# Anupam Hosiery Industry (PVT.) Ltd

Vulta, Rupgonj, Narayangonj, Dhaka  
(+23.77499N, 90.56040E)

10 June 2014

# Observations

## Item 3 – Design check required for punching shear capacity of flat slab floors

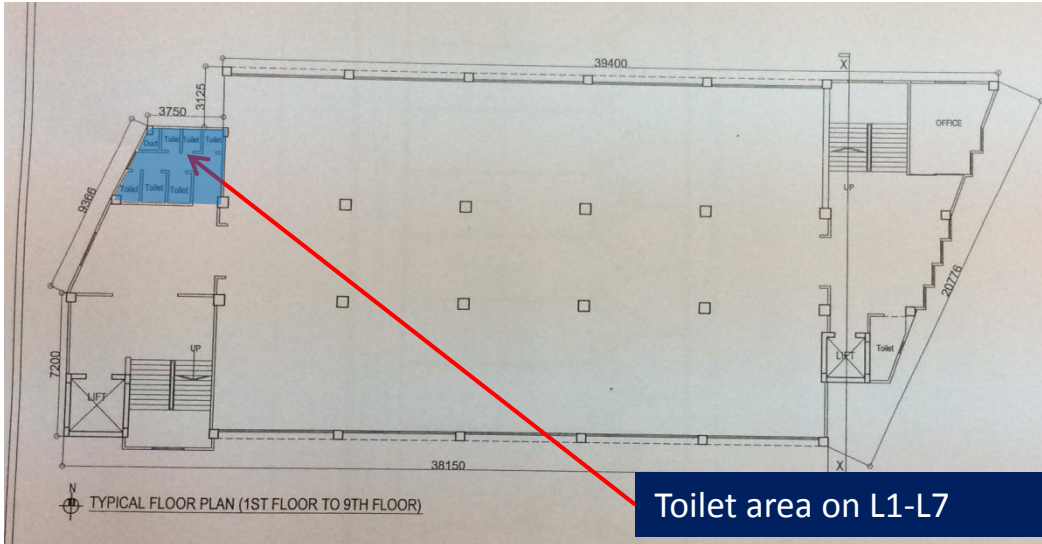
Structural system mainly flat slab floors with column heads. Punching shear capacity to be verified.

# Item 5 – Design check required for the cantilever slab on the south west corner of the Building

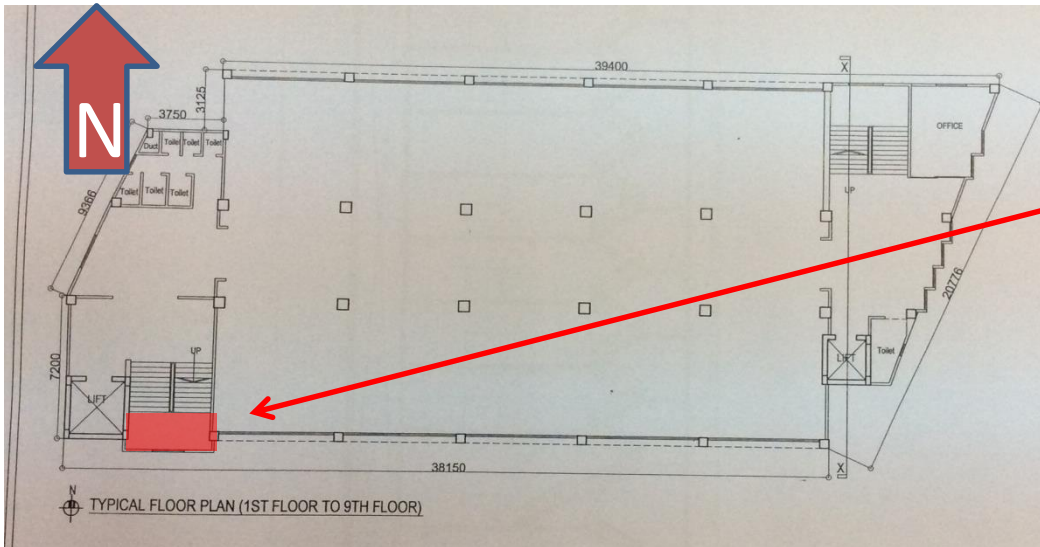
# **Design check required for the cantilever slab on the south west corner of the Building**

Item No.	Observation	Recommended Action Plan	Recommended Timeline
13	Design check required for the cantilever slab on the south west corner of the Building	The Building Engineer is to check the structural capacity of the floor slab in the area indicated and confirm with calculations its capacity to support both floor loadings and façade loadings.	6-weeks
14	Design check required for the light steel roofs as noted	No bracing noted in most of the light weight steel roofs and structures viewed on site.	6-months
15	Design check required for the light steel roofs as noted	The Building Engineer is to assess the adequacy of the structures to resist wind loading (pressure, suction & uplift). Bracing and other remedial measures deemed necessary to be implemented.	6-months
16	Inconsistencies between the Utility Building drawings presented and the as-built structure	Building Engineer to check, collect information and produce accurate and fully complete as-built documentation which is to include the correct sizing of all structural members as well as the reinforcement in each.	6-months

## Item 6 – Design check required for the light steel roofs

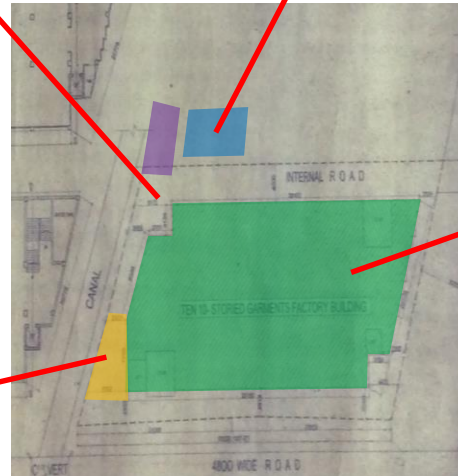
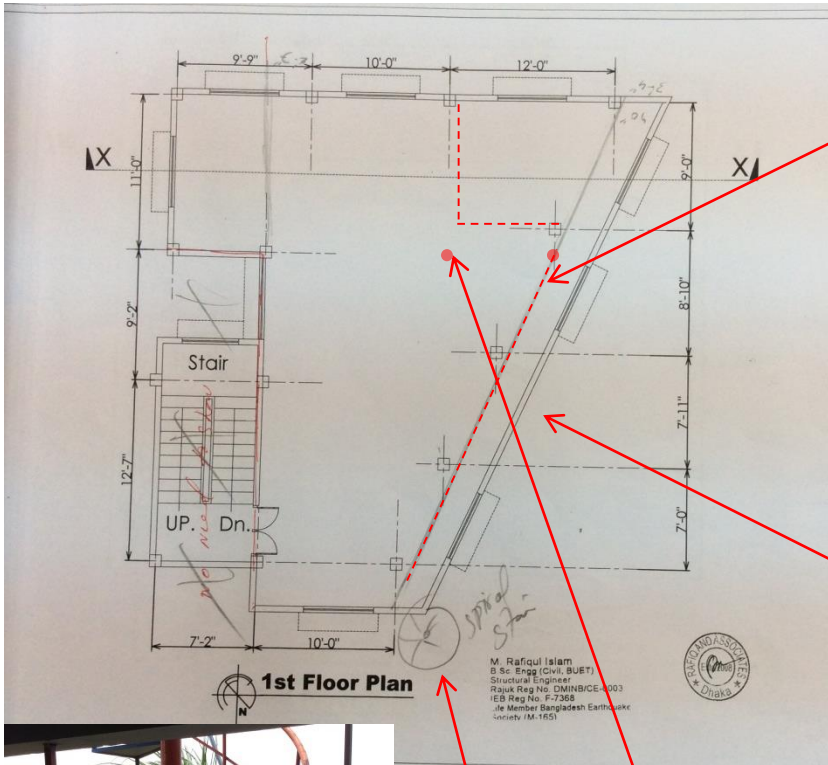
Steel Roof spanning between the Main Building and Childcare Building

Light steel roof to Storage Building

Steel roof of Utility Building

Steel roof of Main Building

# Item 7 – Inconsistencies between the Utility Building drawings presented and the as-built structure

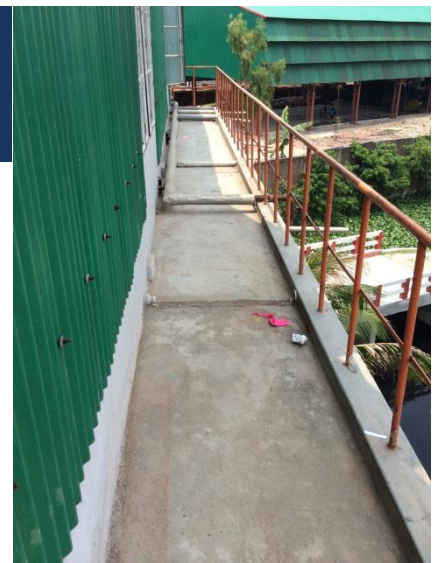
Walls not indicated on drawings

Balcony not indicated on drawings

Approximate locations of as-built columns

Spiral staircase instead of indicated stairs
